PARTS & SERVICE NEWS

REF NO.	AA98040
DATE	April 17, 1998

SUBJECT: CENTER DRIVE SHAFT

APPLICATION: WA180-3 Wheel Loader S/N A80001 and up

CENTER DRIVE SHAFT

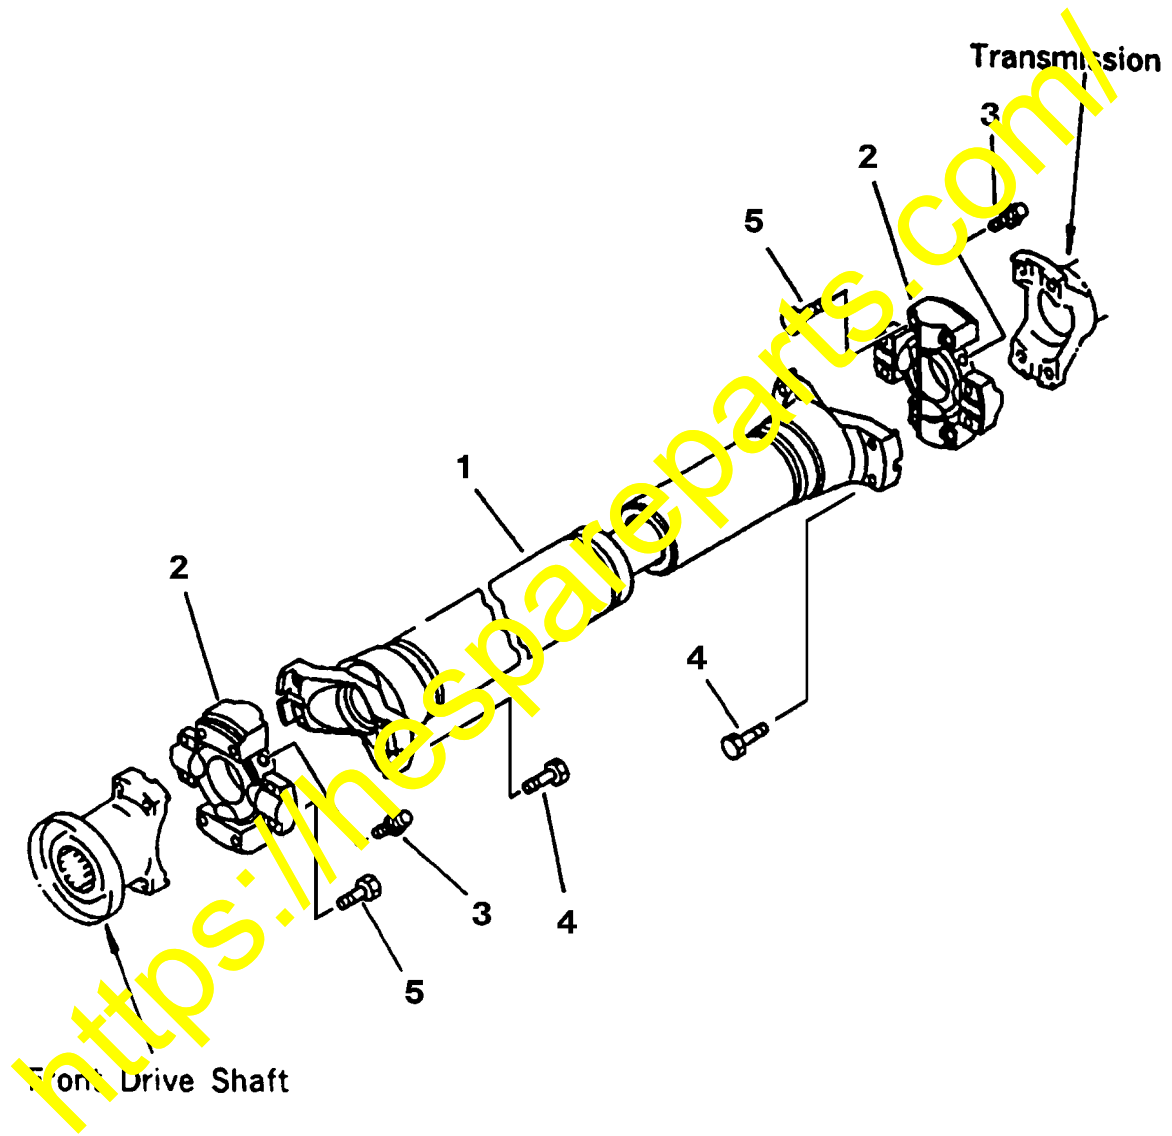
WA180-3 Wheel Loaders built from January through June 1997 had center drive shaft 417-20-A1110, which may interfere with the front transmission yoke when the machine is fully articulated.

WA180-3 Wheel Loaders built after June 1997 have center drive shaft 417-20-A1120, which eliminates this possible interference.

Field campaign A7031 was released to change the center drive shaft of the earlier machines from 417-20-A1110 to 417-20-A1120. There are no machines in the field with the displaced drive shaft.

The serviceable sub-components (spider assembly and bolts) are not interchangeable, and are used as follows:

Item	Part Number	Description	Qty.
	417- 20- A1120		DRIVE
	SHAFT ASSEMBLY, CENTER		1
1	NSS	. SHAFT ASSEMBLY	1
2	417- 20- A1130		SPIDER
	ASSEMBLY		2
3	417- 20- A1020		.. FITTING,
	GREASE		1
4	25 772 R1	. BOLT	8
5	01050- 61045	BOLT	8
